## ARCHITECTURAL REVIEW COMMITTEE – STAFF REPORT

## Advisory Review

**Address:** 117 S Ridgeland Ave  
**Meeting Date:** October 24, 2024  
**Property Owner:** James and Stacy Pfluecke  
**Architect:** Tracey J. Brewer  
**Historic Designation:** Contributing building in the Ridgeland-Oak Park Historic District  
**Zoning:** R-3-50: Single-Family Residential  
**Project Description:** Construction of new garage  
**Requirements:** Garage Policy; New Construction, and Addition

**117 S. RIDGELAND AVE.**  
**OAK PARK, ILLINOIS**

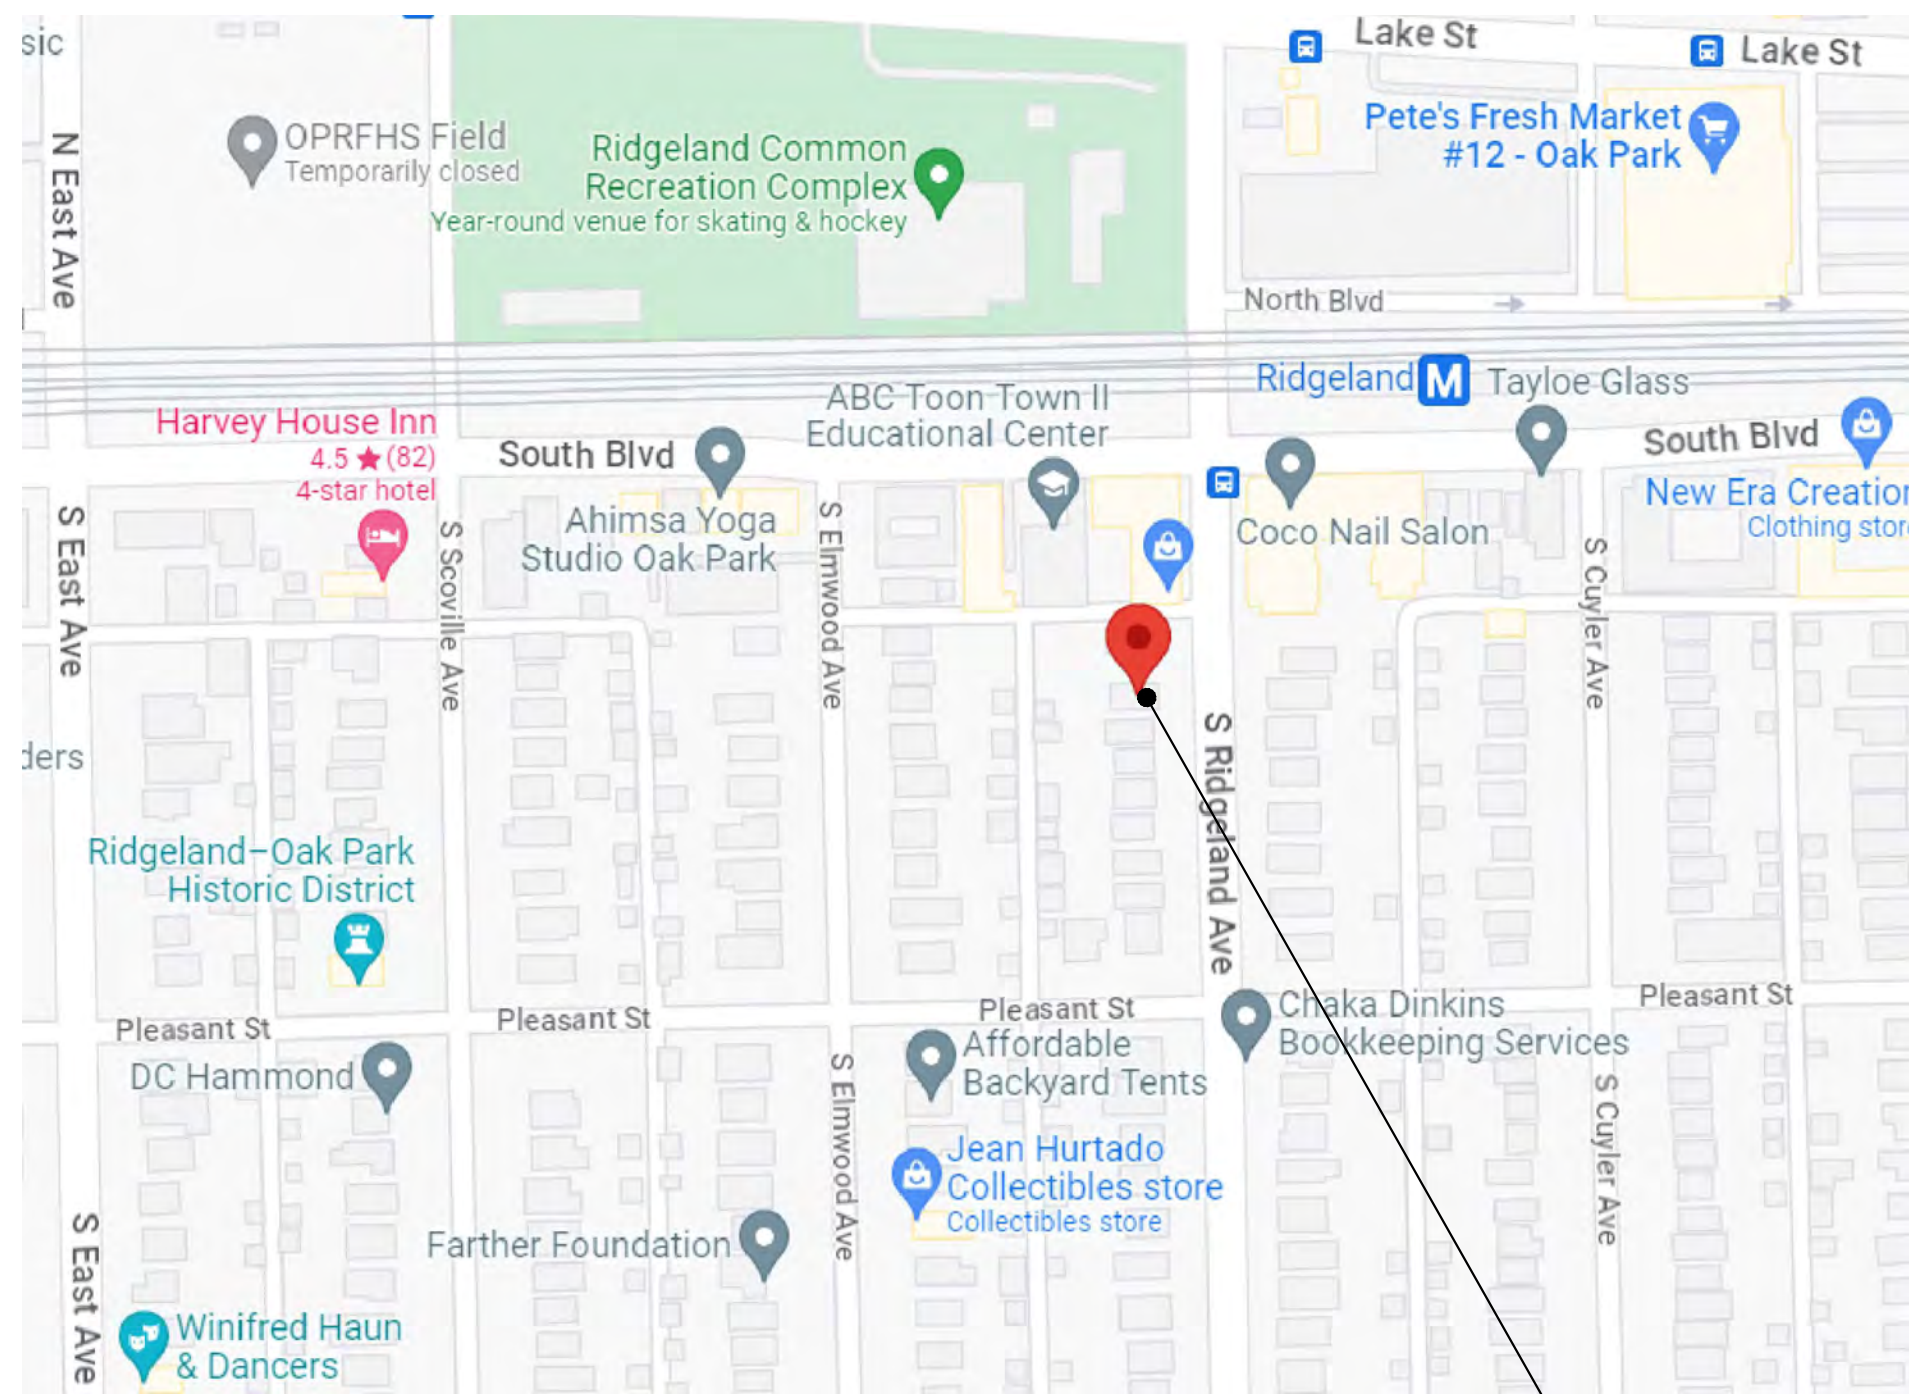
The applicant plans to construct a new 26'x (22'+3') garage with frame construction in a similar location to the existing garage. The new garage will have fixed casement wood windows with aluminum cladding, and painted wood clapboard siding. The Architectural review Committee should provide recommendations based on the Architectural Review Guidelines. Please note that this is an Advisory Review only.
